LICENSEE: Virginia Electric and Power Company
FACILITIES: Surry Power Station, Units 1 & 2
SUBJECT: MEETING SUMMARY OF JUNE 28, 1990

MEETING WITH SURRY AND NRC STAFF
REGARDING COMPONENT COOLING WATER (CCW)

**COMPONENT COOLING
THERMAL BARRIER MEETING
JUNE 28, 1990**

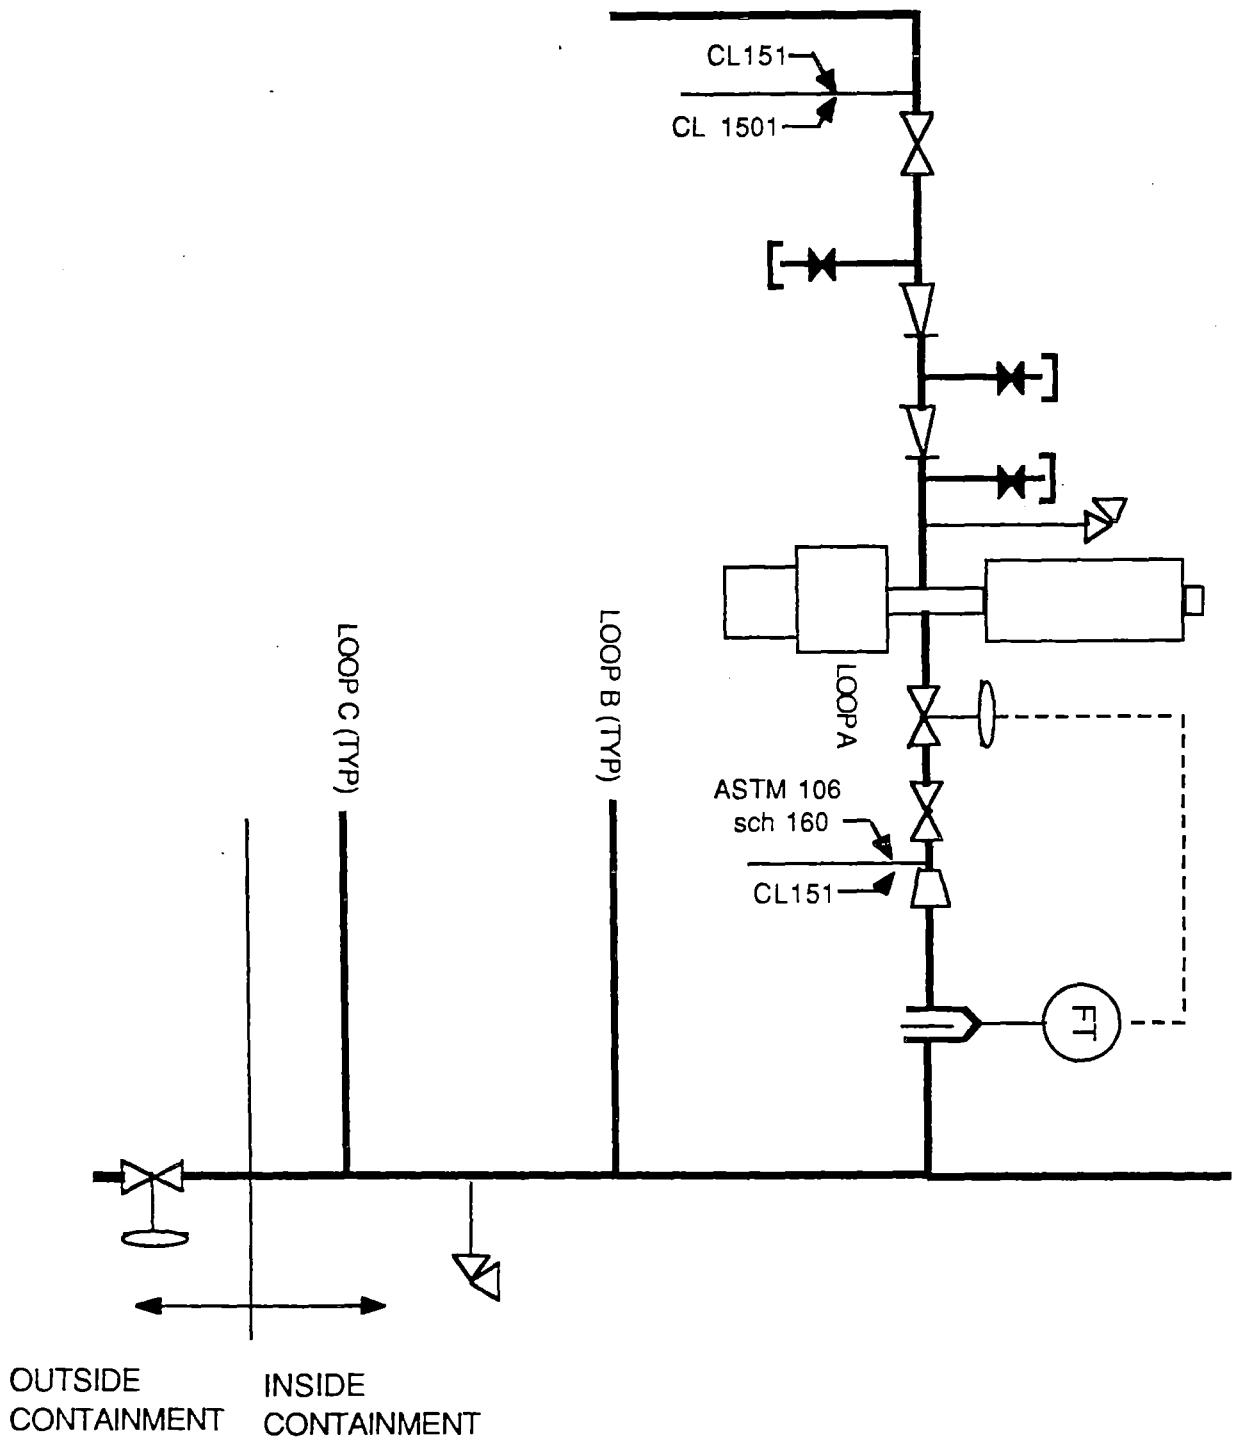
VEPCO representatives discussed various design options they had evaluated, and concluded that, based on long-term maintenance, ALARA, and cost considerations the modifications as shown on Figure 2 of the meeting handout was the most practical approach to resolve this concern. The current CCW piping configuration is shown on Figure 1 of the handout. The section of piping of interest consists of two high pressure check valves to prevent backflow, a safety valve set at 2500 psig located upstream of the reactor coolant pump and an isolation valve that will automatically close should the normal CCW flowrate of 40 gallons per minute (gpm) increase to 50 gpm. Other means are available in the CCW System, such as CCW temperature and radiation monitors to alert plant personnel of thermal barrier leakage.

The proposed changes as shown on Figure 2 consist of replacing the existing containment isolation valve located outside containment with a 1500 lb. valve and installing another 1500 lb. containment isolation valve and a local, manually operated 1500 lb. block valve inside containment. In addition to the two aforementioned automatic containment isolation valves closing on containment hi-hi pressure, they will also close on a high CCW flowrate signal. The emergency operating procedures will be revised to address this accident scenario. In response to NRC staff questions the licensee will inform the NRC how they will address post-LOCA thermal expansion between the two new automatic containment isolation valves which has the potential to result in unacceptably high pressures between these two closed valves. VEPCO was also asked to advise the NRC staff if the two new containment isolation valves and associated new piping are being designed to current regulatory requirements or to the original plant licensing basis. Because of long lead times associated with the procurement of the new valves and instrumentation, these modifications will not be completed until the Cycle 11 refueling outage, currently scheduled for the first quarter of 1992.

The NRC staff agreed that VEPCO's design approach and implementation schedule appeared reasonable.
